**Z22-24**  
**Hotel Redevelopment**  
**REVISED**

Property Owner: Legacy Hotel of Medina LLC  
Applicant: Jim Gerspacher  
Location: 253 and 257 South Court Street  
Zoning: C-2 (Central Business)  
Request: Revisions to an Area Variance to Sections 1135.06 regarding maximum building footprint and minimum front setback, 1135.08(a) regarding the location of parking in the front yard, and 1135.13(b)(4) regarding the division of the building into storefronts and a new Area Variance request to Section 1135.06 regarding maximum building height

The current application revises the footprint and height of the hotel building, updates building elevations, and provides greater detail. In addition, the proposed hotel incorporates a first floor restaurant, four stories of hotel rooms, a partial fifth story with a rooftop lounge, and a small one-story area located at the rear of the building for deliveries. The proposed revision does not alter the previous approval of Z24-08.

SHEET NAME ROOF OUTLINE & HEIGHT	SHEET NO. HSK05
-------------------------------------	--------------------

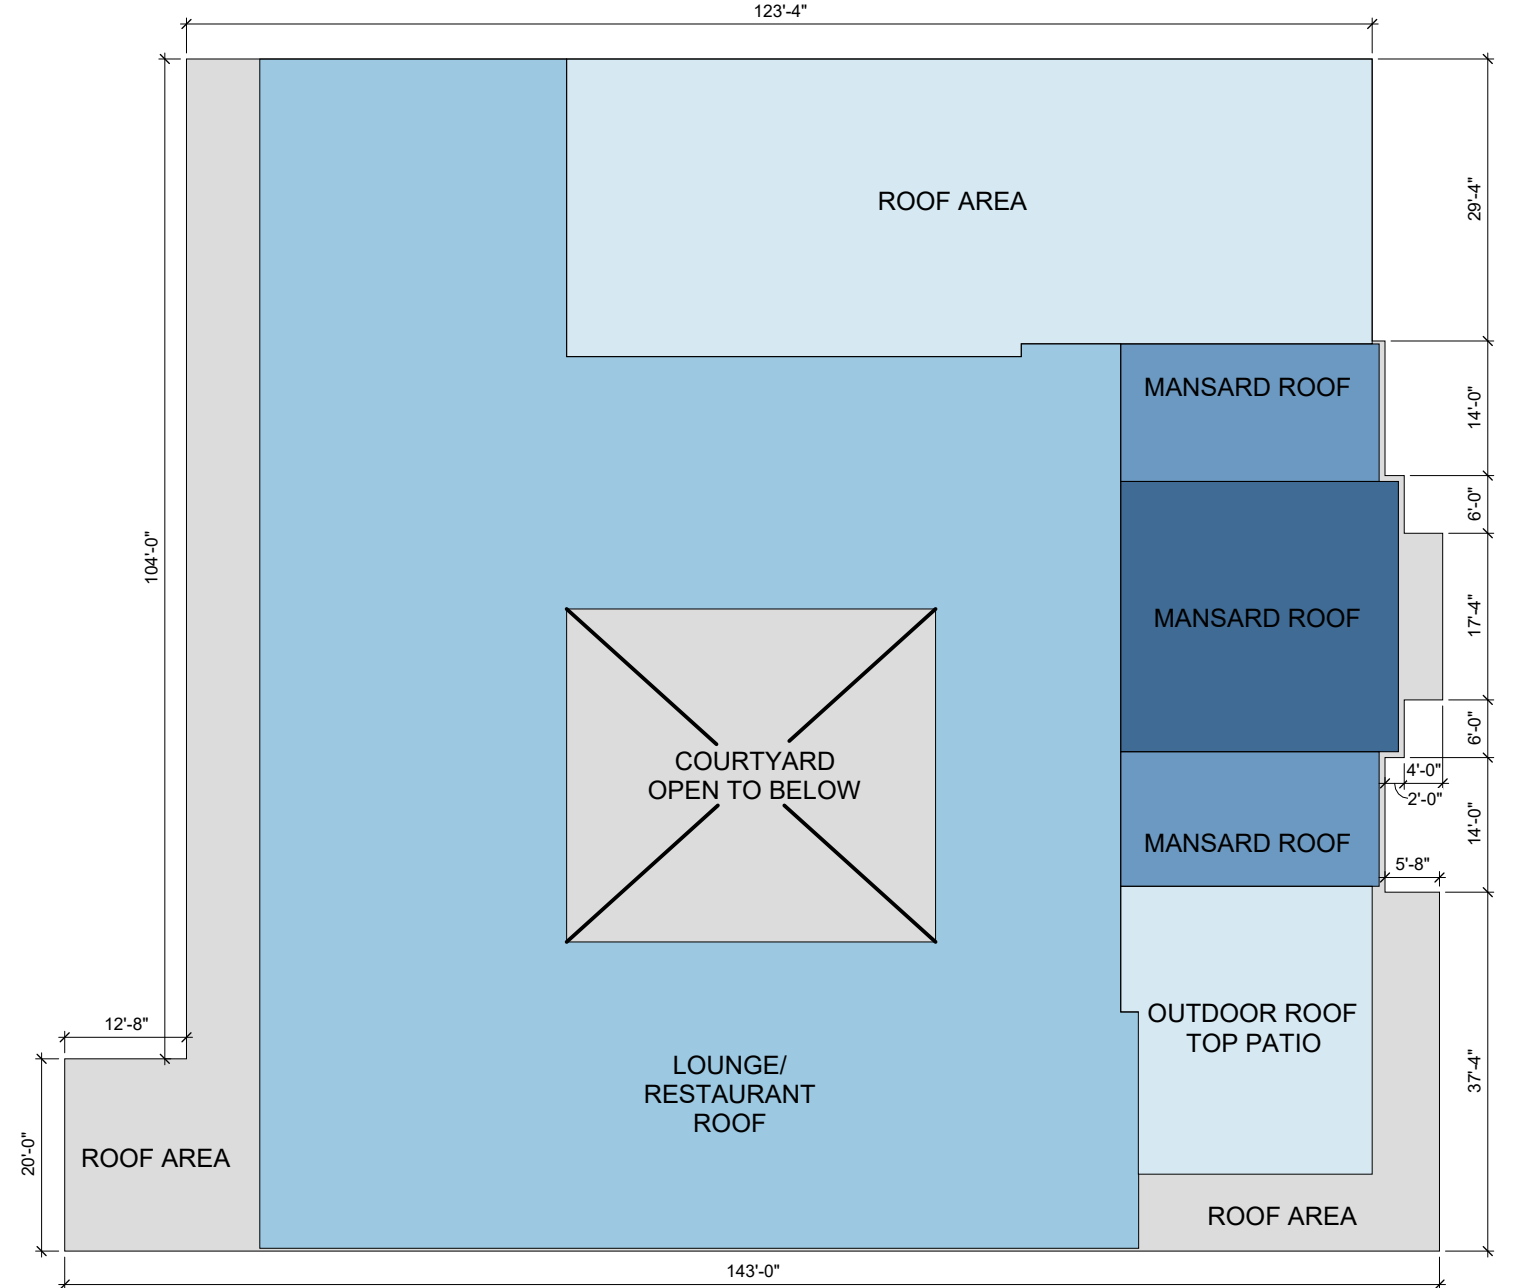
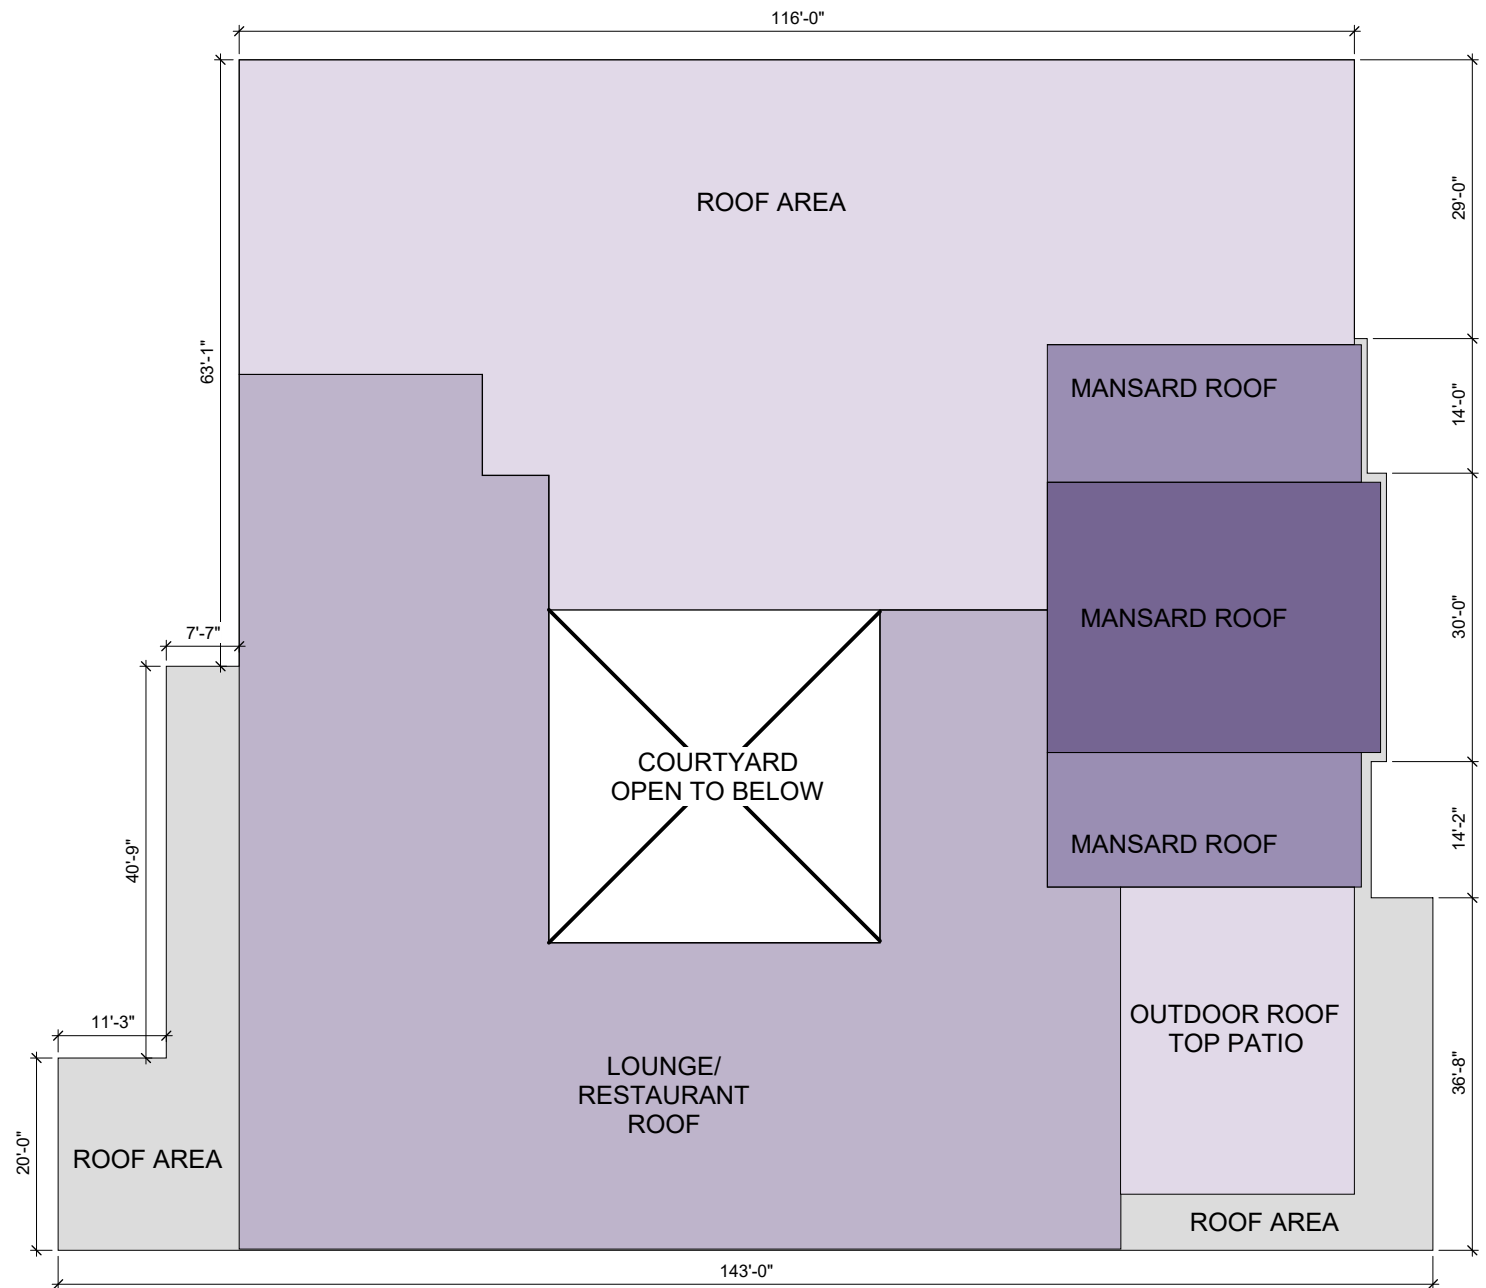
**Building Height** – The effective building height of 55 ft. was previously approved by the Planning Commission, which can approve a building height up to 60 ft. The overall effective height of the building has increased by 6 ft. to sufficiently accommodate mechanical components. The effective height of the revised building is 61 ft., which is the roof line of the building. Decorative architectural features that do not have functional interior area above this height are not included in the effective height of the building.

- 2- Height increase: the original approved elevations show the top of roof at 55'-0", the updated drawings show 61'-0". The additional height requested is 6'-0" higher than the previously approved plans. This increase in floor height accommodates more advanced HVAC systems than previously approved without sacrificing quality of interior spaces. Unlike the previous design, no suites will have exterior louvered grilles on the newly proposed plans. Without the new height variance, the available methods of construction are narrowed to options that are not as feasible and accommodating mechanical duct work becomes difficult.

The mansard roof was previously approved at 66'-8", the proposed is at 71'-0". This is purely an architectural feature that gives the hotel its historical character and is visible on S Court Street from all sides. The added height is not being used to generate profit to the developer(s).

UPDATED  
HOTEL FOOTPRINT  
16,013 SF

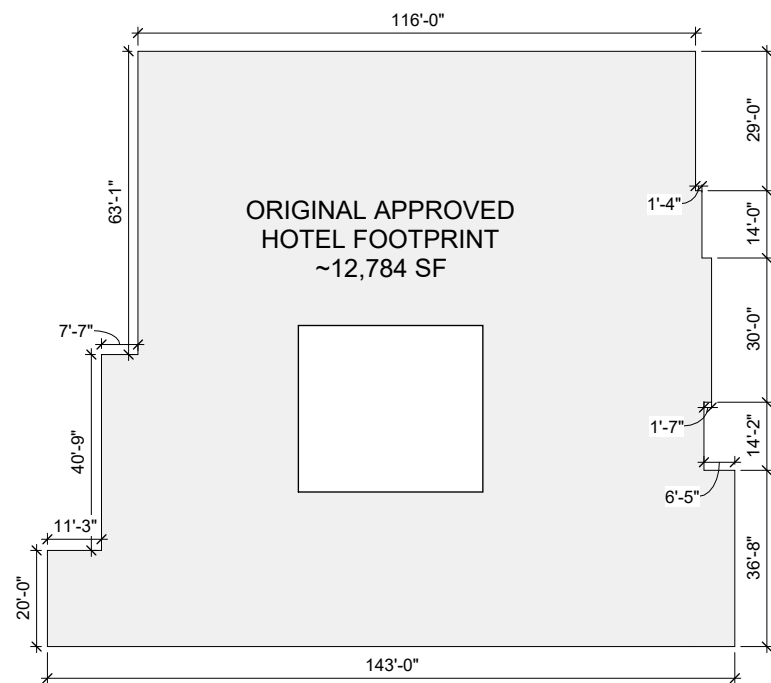
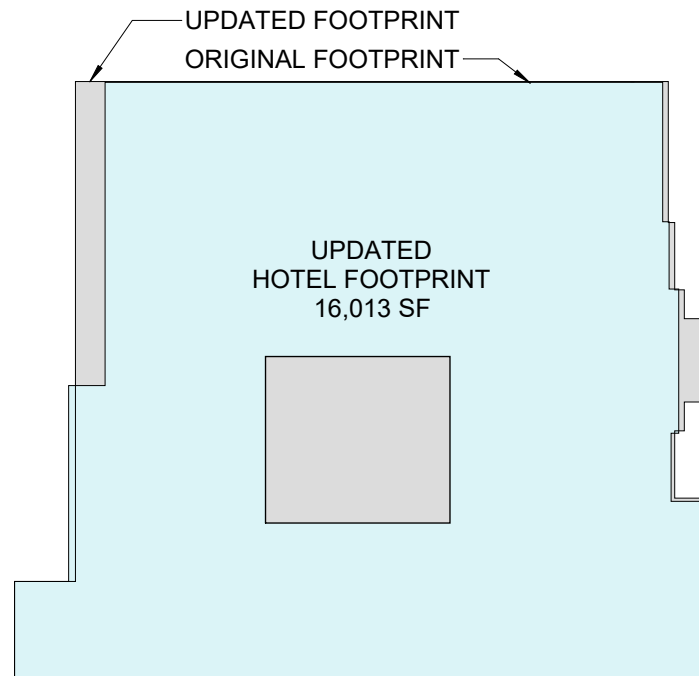
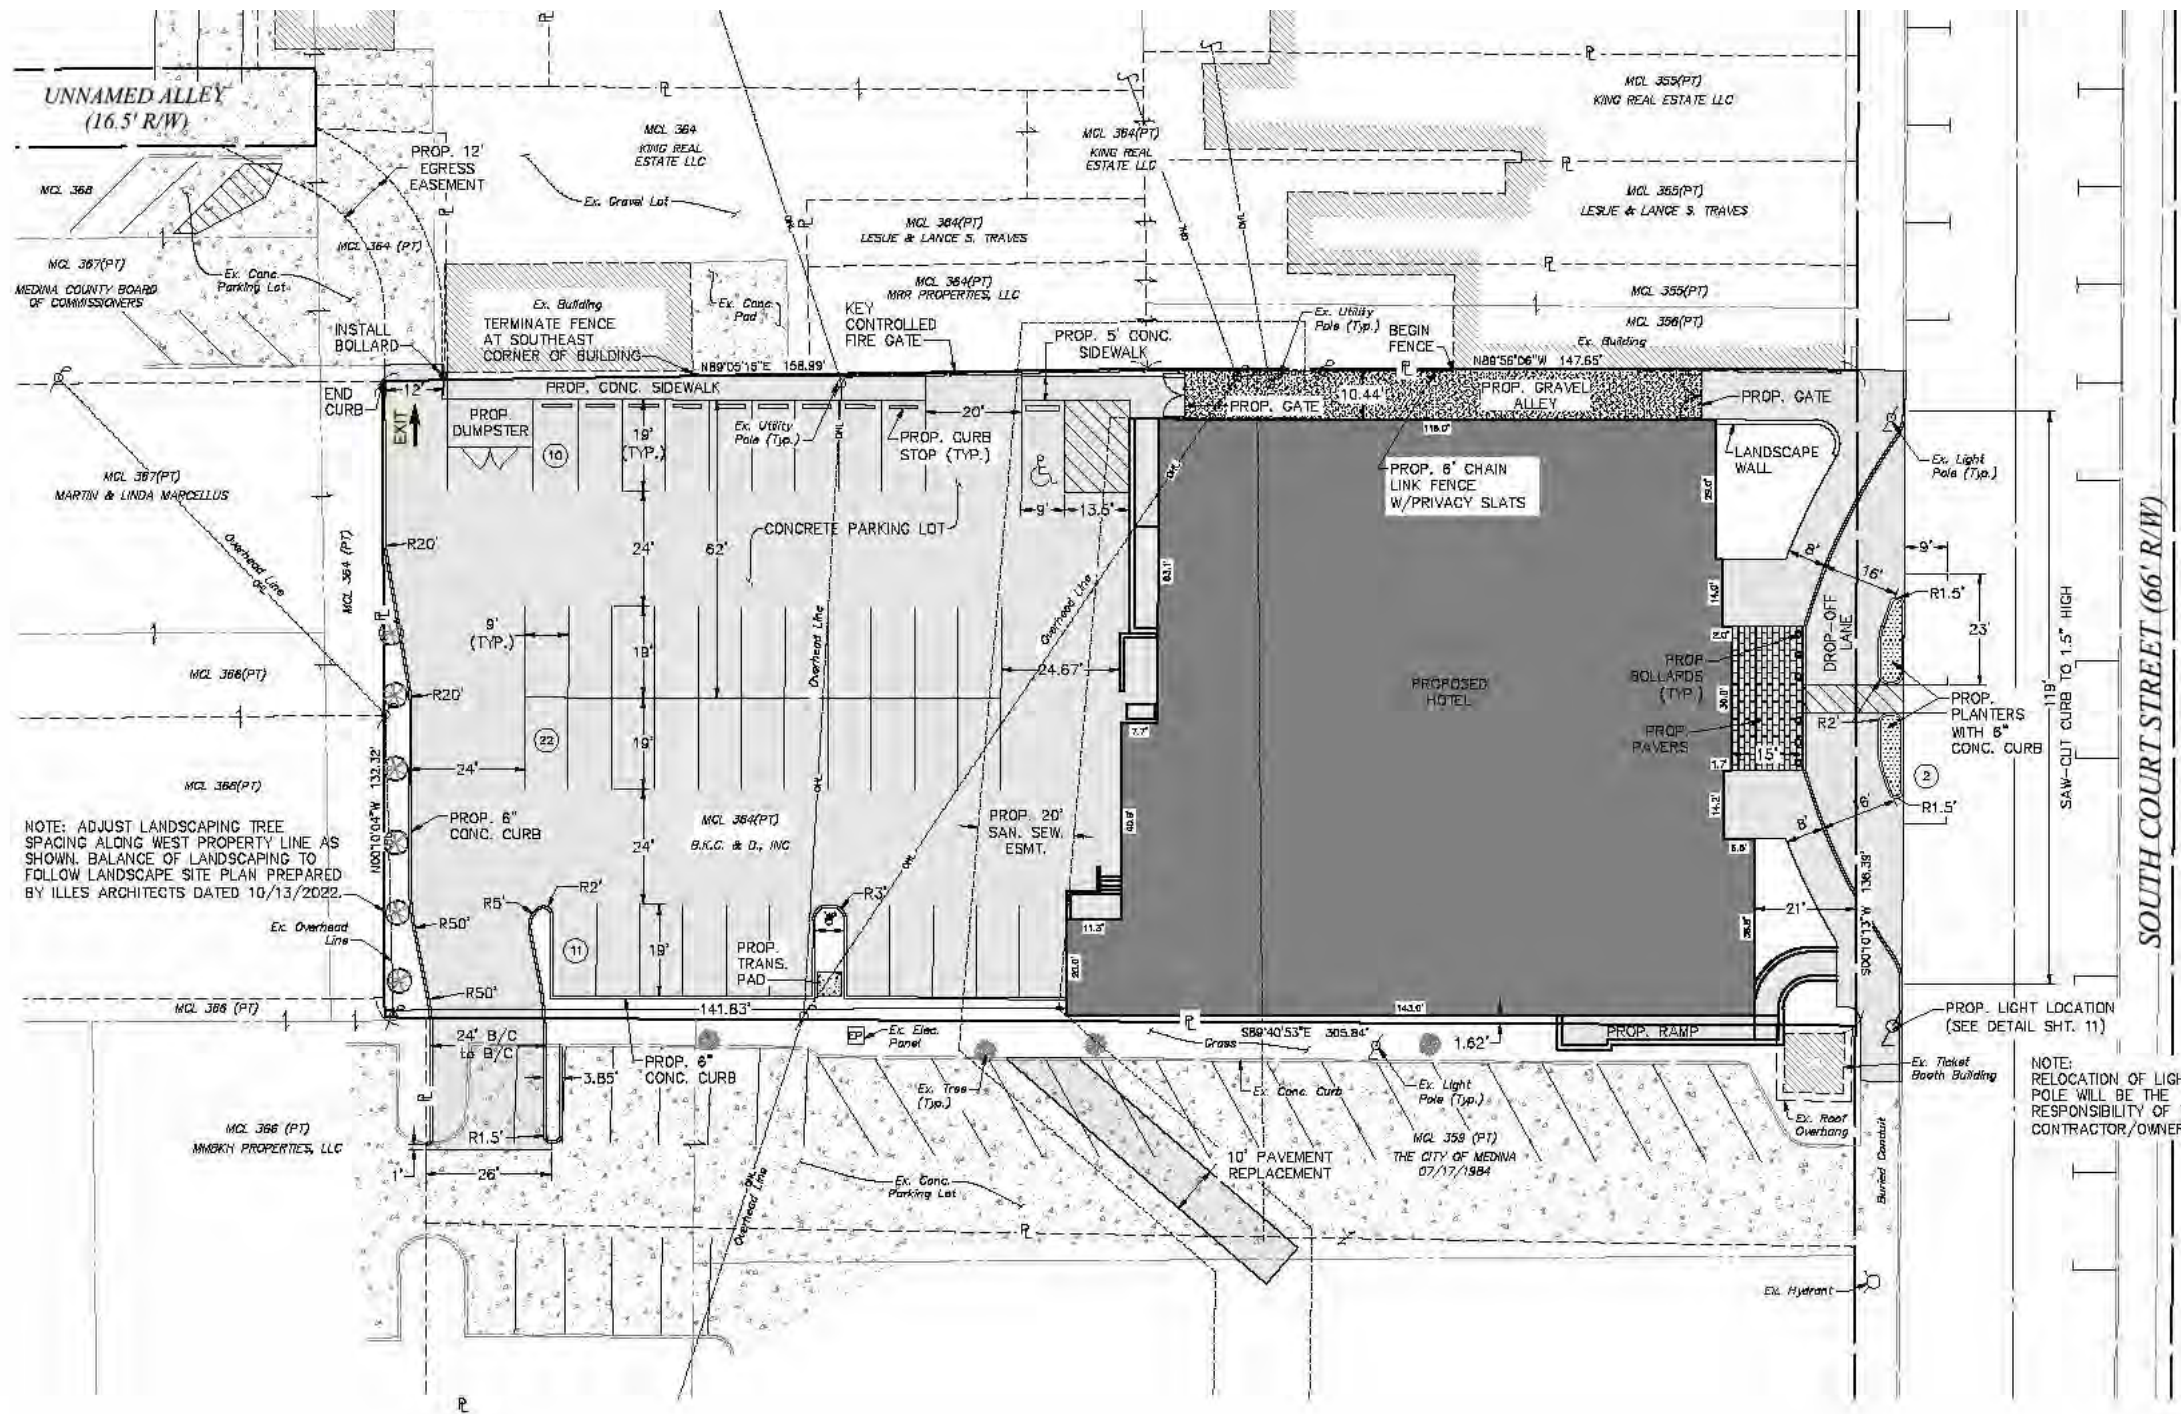
**Maximum Building Footprint** – The previously approved building contained an open courtyard in the center of the entire building. The proposed building’s footprint has increased due to the removal of the courtyard on the first floor and modifications to the east and west sides of the building. The open courtyard remains on all other floors of the building and the width of the building adjacent to South Court Street remains unchanged. The applicant has provided a detail of the changes in the building footprint on the “Site Plan and Building Footprint Original” page.

- 1- Footprint increase of 3,229 sf: Previously approved footprint was approximately 12,784 sf and proposed is 16,013 sf.

While there are minor changes to the perimeter dimensions, the square footage increase is largely due to the infill of the courtyard on the first floor. The courtyard remains a feature in the project accessed by guests on the second floor. The exterior perimeter of the hotel has grown negligibly, and it would be nearly impossible for someone to see that increase from outside the hotel. Please see below a snippet showing both footprints overlapped (blue is original footprint – gray is updated)
